**Re: *Hidalgo County Precinct # 1
Delta Outfall System Drainage Improvement Project
Project # 6536-94-0309-5200-9000***

Please consider this letter as a request for approval of a change order and time extension to complete the above reference project.

CHANGE ORDER No. 1 TABULATION
 DELTA AREA OUTFALL DRAINAGE IMPROVEMENTS PROJECT
 URBAN COUNTY PROGRAM

Sheet Title: LEVEE (FM 491 RD.) CROSSING

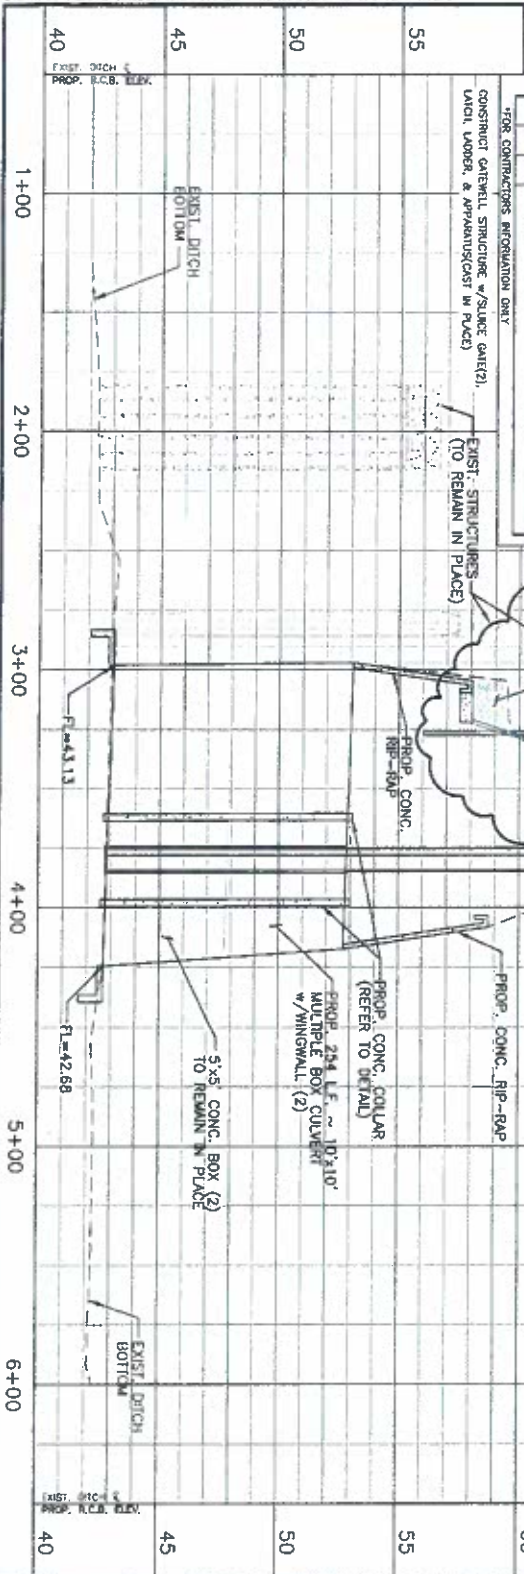
The change order is required to comply with International Boundary and Water Commission (IBWC) and to stay inside the drain ditch right-of-way. The fourteen (14) days time extension is due to the delay from IBWC in approving the sluice gate submittal.
